# Ashokan Watershed Stream Management Program

## Esopus Creek at Woodland Valley Restoration Demonstration Project

### Evaluation October 30, 2008 Meeting Summary

Figure 7. Post April 2005 flood topographic survey with schematics of remaining project features.

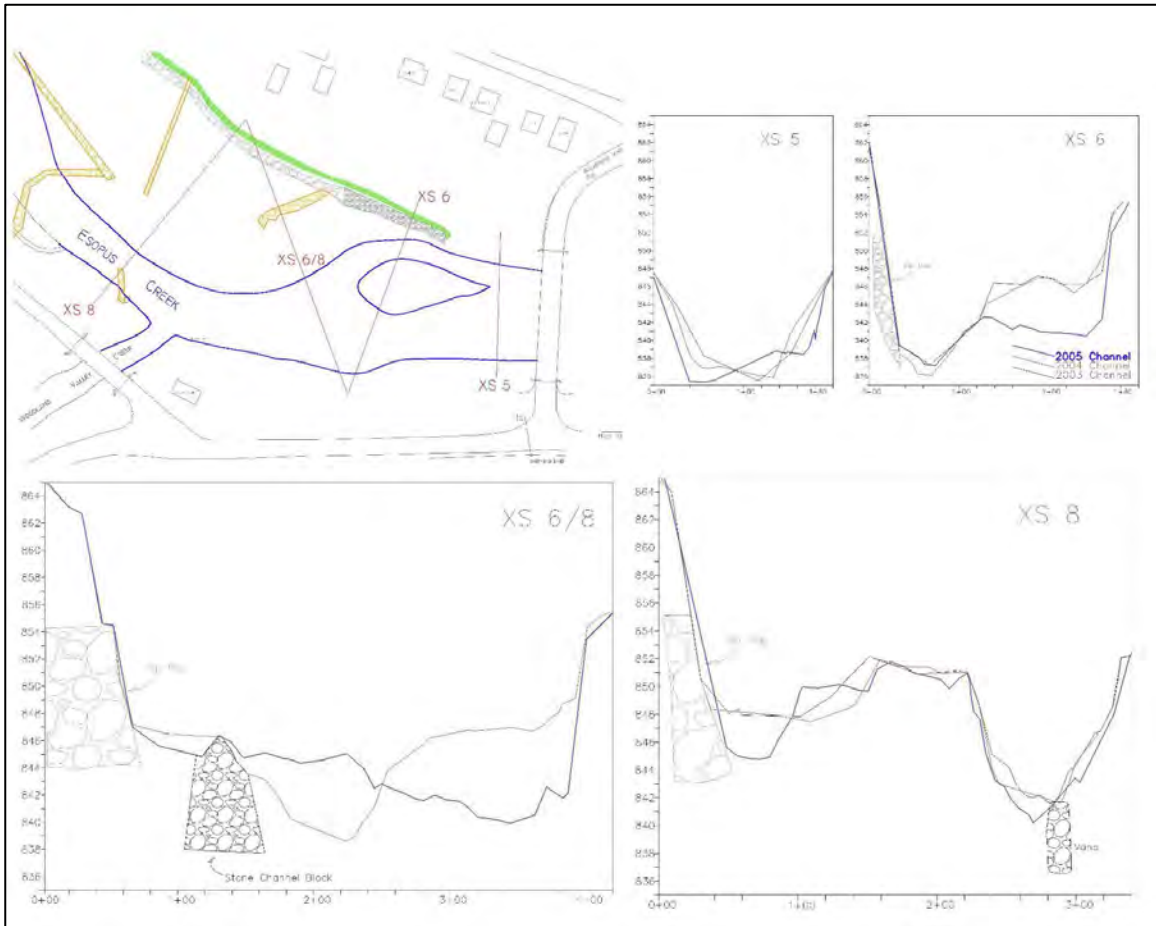
placed at the upstream, “middle” and downstream ends of the filled channel (Figure 3). While the flood plain experienced minimal change from the frequent inundation prior to the April 2005 event it did experience significant change evident following the event (Figure 7). Deposition on the streamward side and scour between the middle and downstream channel blocks caused at least 6 feet of relief in places along the surface. It is noted that Craig Fisichenich anticipated these adjustments (as well as those of the in-channel structures) and informed DEP and UCSWCD on several occasions of the expected changes. The semi-frequent inundation of the left margin of the flood plain from the upstream overflow channel has helped to create a small swale (bound by the channel blocks) that actually appears to function as a riparian wetland. The downstream channel block previously formed the channel boundary but currently an extensive point/lateral bar has prograded the flood plain several meters downstream (Figure 7.) The riprap key trench in the bar below Woodland Valley that keyed the lower weir into the railroad grade embankment was lost during the April flood.
